SERVICE BULLETINS

Manual P/N 02980501 (08/05)

Alamo Industrial

Failures of the mower push-pull switch:

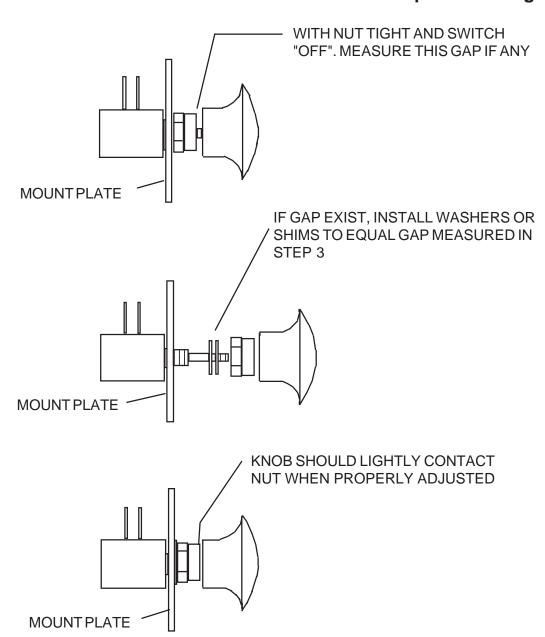
Alamo has recently received reports of failures of the referenced switch. The failures modes are:

- (a) Knob pulls off rod.
- (b) Rod and Knob pulls out of switch body.

Test performed on numerous switches indicates that the (b) failures are due to excessive force being applied to the knob when shutting off the mower. Specifically, the knobs are usually roughly slapped to turn the mower off. After internal parts of the switch are damaged, the rod can then be pulled out easily. The (a) failures are due to the knobs not being securely tightened.

To prevent these failures from occurring, or to replace a damaged switch, use the following procedure to adjust the travel of the switch. (See attached diagram).

- 3. Measure the distance (if any) between the knob and the nut. Record the measurement.
- 4. If a Gap exists between the knob and the nut, remove the knob.

- 5. Remove the nut and install the same thickness of flat washers that was measured in step 3. Install and tighten the nut> DO NOT install more washers than needed to take up the space. Flat Washer Part No. 00023500 or equivalent can be used.

Repair Procedure for Welding Cracks in Boom Heads:

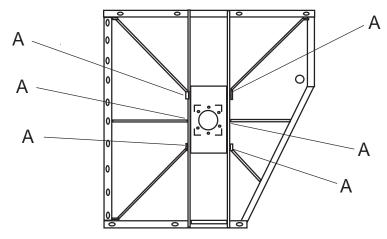
If cracks appear in the welds at points "A" as shown above, use the following procedures to repair head.

- 1. Grind a groove at the site of the crack and clean the area to be welded.
- 2. Weld the crack making a 100% weld.
- 3. After repairing the cracks, prepare the sites for installation of the gussets.
- 4. Position the reinforcing bar gusset part no. 02970111 if 90° or part no. 02970112 if 48° over the X-Bar as shown in drawing next page. Weld with a 1/4" fillet weld on the bottom and an edge weld on top. DO NOT weld the ends.
- 5. Clean and paint the area.
- 6. Reassemble any parts that were removed.

New Piston Pump used on Machete:

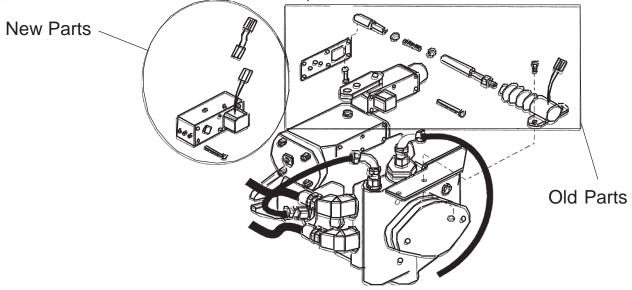
A new Pump is being used on all Machete Boom Mowers. The new pump utilizes a solenoid valve and manifold (New Parts) to control pump swashplate movement instead of the former (Old Parts) electric solenoid, Spool valve and adjustable linkage. All other parts of the pump remain the same. The new parts provide for more positive trouble free operation of the pump and do not require adjustment.

There will be a harness adapter required to connect the new two wire connector to the old three wire harness. Adapter and instructions are included in replacement parts. When the former (old part number is ordered, all the new parts will be provided.

New Seal Protector Added to Blade Bar Assembly:

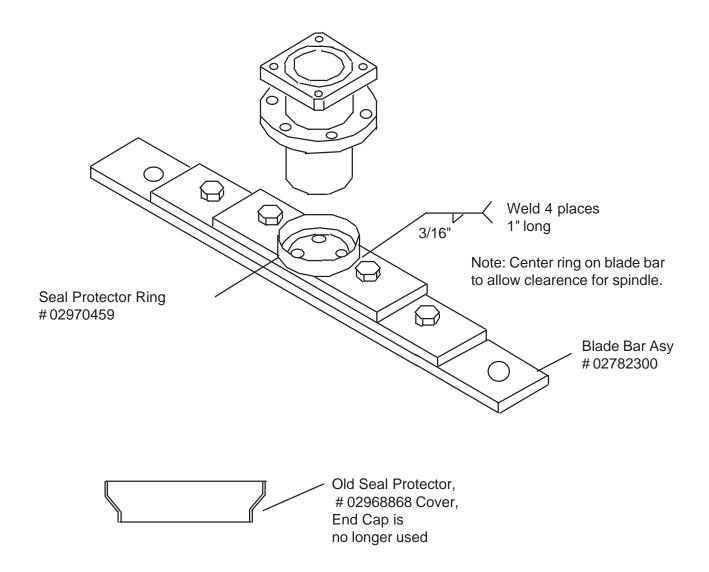
A new seal protector has been designed to aid in preventing material from wrapping around the seal cover area. While nothing can completely prevent material from getting to the seal cover, the new seal protector should greatly reduce the probability of spindle seizures due to these causes.

If a machine is operating or is going to operate in an application in which material is likely to wrap around spindle, the following parts can be ordered and installed. The old seal protector (# 02968868) which is on the spindle will be removed and discarded. The Old Part No. 02968868 will be ordered but the new Seal Protector Part No. 02970459 will be shipped with installation instructions. If only the new Seal protector is ordered the instruction sheet will not be shipped.

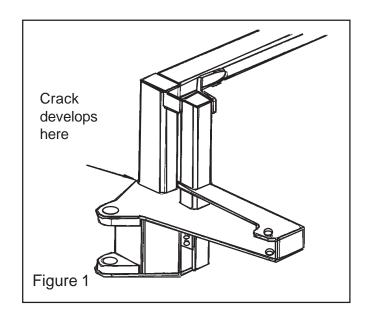
There have been some cracks in the main frame of some machete mowers

If a crack should develop (See Figure 1), use the following procedure to make repairs untill a permanent repair is developed. NOTE: This repair will aloow the machine to continue operating while a long term correction for the problem is being developed.

- 1. Grind out old weld (crack) and weld the crack, Do not use an excessive high repair weld as you will need to grind repair weld down smooth.
- 2. Prepare a piece of 1/2" X 6" HRFB cut to length (See Figure 2). The bottom should rest against the King Post frame and the top should be with in 2" of the top of the frame, this will determine the height of the repair plate (See Figure 3). Bevel the bottom side of the plate that is towards the frame to allow for the old weld. This will be evedent if you test fit the repair plate.
- 3. Place the stiffener repair plate against the vertical memeber of frame (as shown in figure 3) and tack weld into position, Make sure repair plate is flat against the frame.

Interference between Tube Clamps and Main Frame:

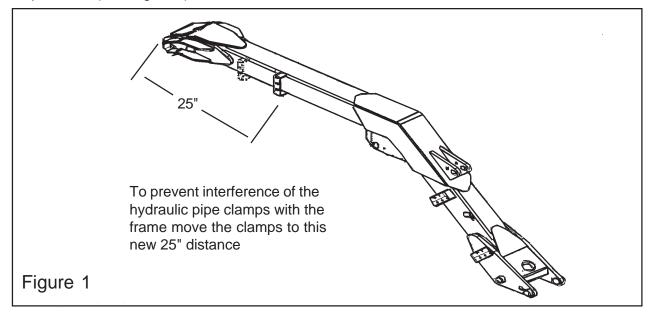
It is possible that the boom hydraulic tube clamps may contact the main frame when boom is raised to its highest position. This condition effects only machines with certain frames. If you have a machine that has this interference problem use the procedures described in this bulletin to correct the problem. (See Figure 1).

If the parts on your unit are damaged, loosen the six bolts that hold the three tubes. Cut the bracket away from the boom. Relocate the bracket on the boom so it clears the frame. Weld in place and paint. Tighten the six bolts. Total time to perform this modification will be approximately 1.5 hours time or less. If parts are required there is a kit that can be installed, the Kit # 02971938.

Tilt Link Arm Stop:

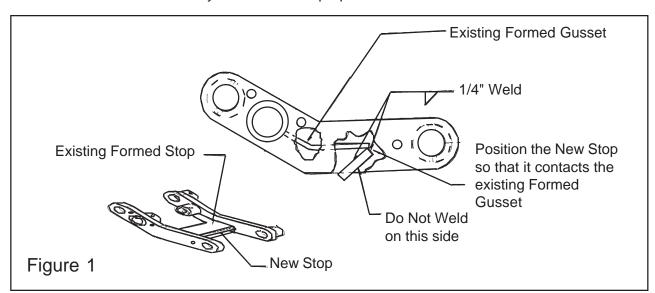
Some Machete models may exhibit interference between the head tilt cylinder and the cutter motor support plate. This can result in a bent head tilt cylinder rod, a damaged cylinder gland cap, or a damaged cutter motor housing.

A stop made from 1/2" X 2-1/4" HRFB X 6-1/2" long should be welded to head tilt link arm weldment as shown in figure 1. This will require welding and painting.

To locate the proper angle position of the new stop, carefully retract the head until the cutter motor support plate and the head tilt cylinder has a clearance of 1". Use caution, do not damage cylinder when retracting the head. Place the new stop plate in the head tilt link weldment and lay it flat on the dipper arm. Mark this position, and weld the stop in place as shown in Figure 1. It is important that the stop is installed so that it flatly contacts the dipper when retracted in order to avoid point loading on the boom. Extend and retract the cylinder to ensure proper installation.

Figure 1

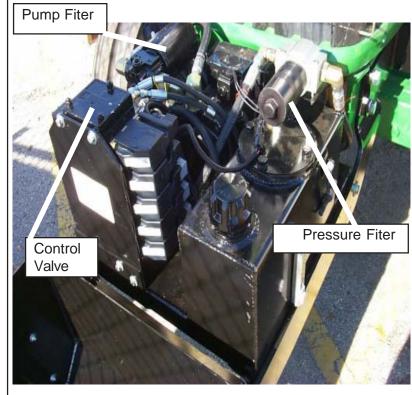
The 2001 Machete will reflect a change in the way some of the components are mounted to the tractor. New Machete units received from the factory, or assembled by dealer after S/N MB21-01572 & UP or MB24-01245 & Up will have the control valve in a new location. It will no longer be mounted on the frame. The Control Valve will be located under the front pump cover in the front of the tractor. This change was made to better protect the Valve and its components from debris and

As you can see in figure 1, the valve is fastened to a plate that is mounted to the units hydraulic tank. The Pressure Filter was relocated to a bracket on top of the tank. Both the Pressure Filter and the Pump Filter are accessible and can be changed with minimal effort. Sepaarate hose exstension were used to extend the hose reach to the front of the tractor. If a hose connection is not easily accessible, then the valve and mounting plate can be unfastened an arranged to allow for romm when servicing.

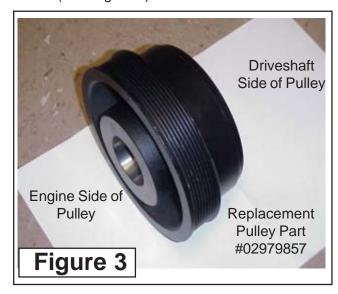
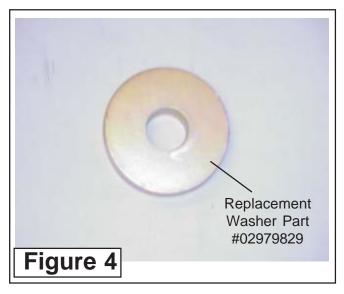
In an effort to comply with certain requirements in regard to Tier II Emission Standards, Deere and Company initiated a change to the crank shaft pulley on many of the new 6020 series tractors. This was a random change, which did not affect all tractors. In addition, a specific serial number break does not exist to identify the affected units.

<u>The Tier II pulley</u> can be identified as a 5 spoke design as indicated in the figure above (See Figure 1). This pulley must be changed to the tapered lock, solid cast pulley as shown to allow adaptation of the required front pump drive system used to power the Alamo Industrial products. (See Figure 2) To change the pulley:

Remove the original pulley retaining bolt, shouldered washer and pulley. (See Figure 1) Clean nose of Crankshaft using LOCKTITE® number 7649 clean and cure primer. Place a light layer 2 mm to 3 mm (.079 - .118 in.) of LOCKTITE® brand adhesive number 680 (TY15969) to the leading edge of the crankshaft nose.

Install the replacement pulley (P/N 02979857) If any paint inside of pulley it needs to be removed. Make certain to align the pulley with crankshaft, install pulley. (See Pulley Figure 3). Do not hammer on Vibration Damper (Pulley) it must be handled in a way that avoids impact damage. Make certain that you installed the Locktite primer and adhesive as described in previous step before you installed the pulley, this is very important.

<u>Install the new retaining washer</u> (PN 02979829) so that it fits flat against the pulley. The original factory washer will not be used. (See Figure 4) Use the original Factory Pulley retaining Bolt (See Figure 1).

Install the original factory retaining bolt and torque to John Deere Specifications 500 N-m (369 ft. lbs). Check John Deere Service instructions for to asure proper Torque of Crankshaft Pulley Retaining Bolt has not changed. (See Figure 1 for original Bolt) . Pulley retaing bolt must be dipped in clean SAE30 oil before installing bolt.
